SHOWN ARE CHANGES REQUIRED FOR DASMA 115

MODELS:
1030, 1035

PART NAME:
WINDLOAD RESIDENTIAL PAN DOOR
W2 C

DWG. NO.
WL-033

SECTION A-A IMPACT

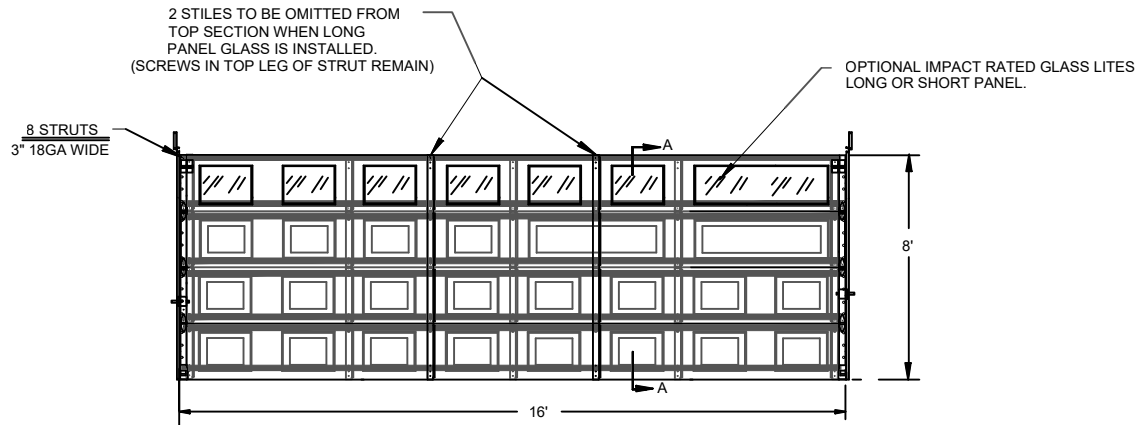
11 GAGE GALV. STEEL COMMERCIAL
BOTTOM BRACKET ATTACHED
WITH 6 FASTENERS
